Public Health, Seattle and King County

Site Design Application Form for Individual On-Site Sewage System (OSS)

Record I.D. Number: ON 0138852  
Department Use Only

Approximate Site Address: 11235 165TH Ct. NE

# Site Plan On Site Sewage Disposal

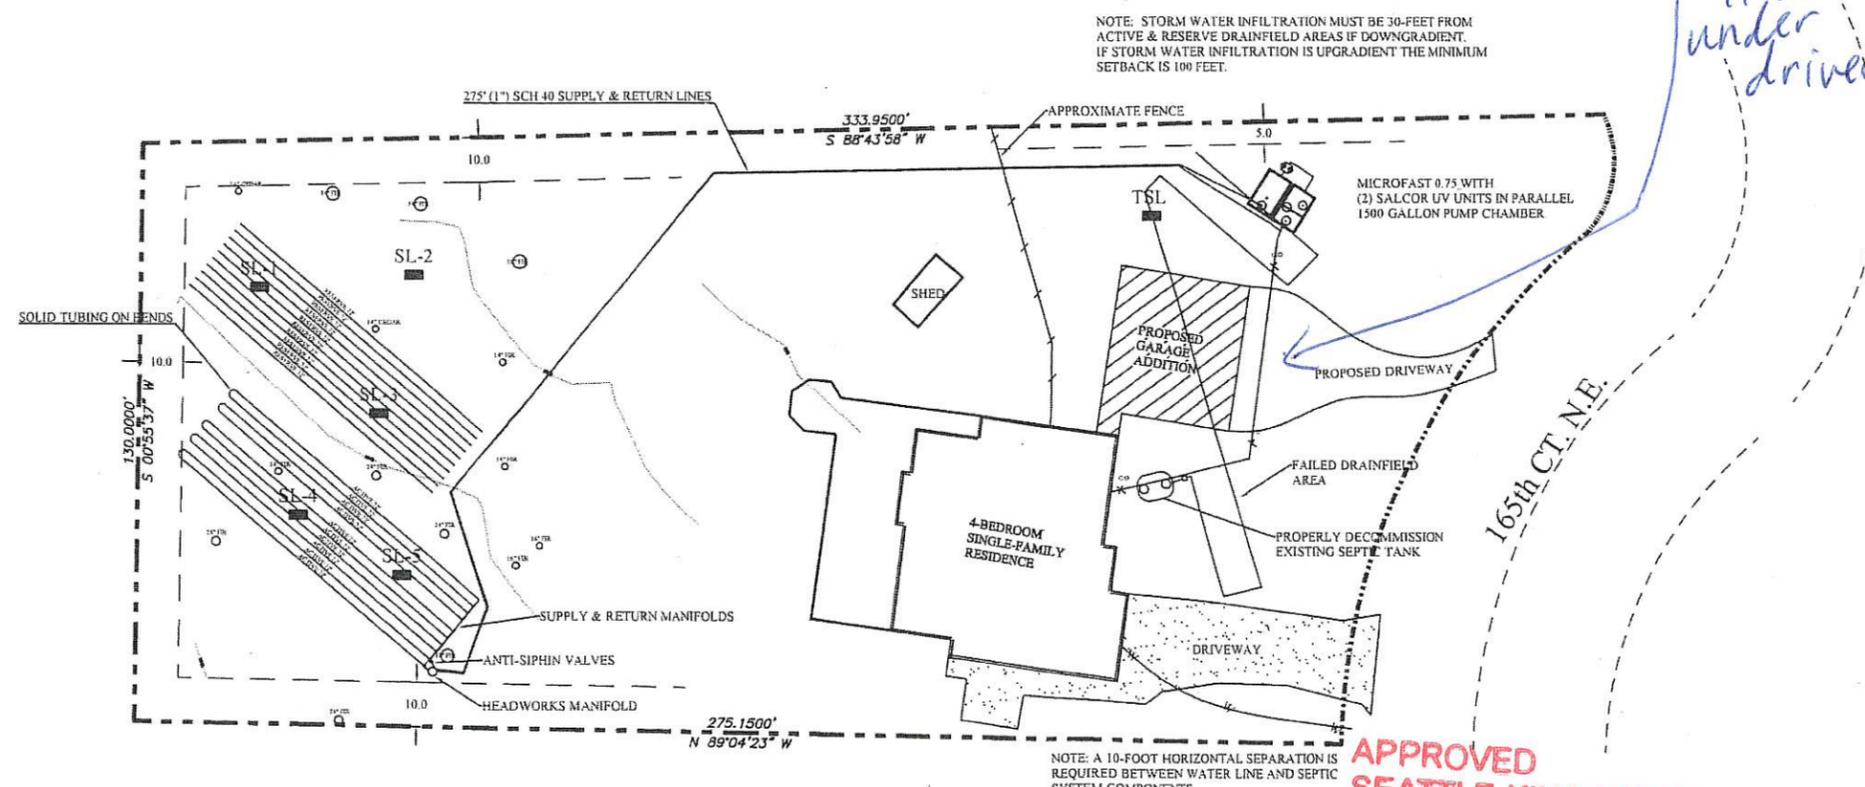
Comments: Prior to stab-out, a non-conforming sewer transport line must be sleeved under driveway. Notice on title is required.

*sleeve sewer transport line under driveway*
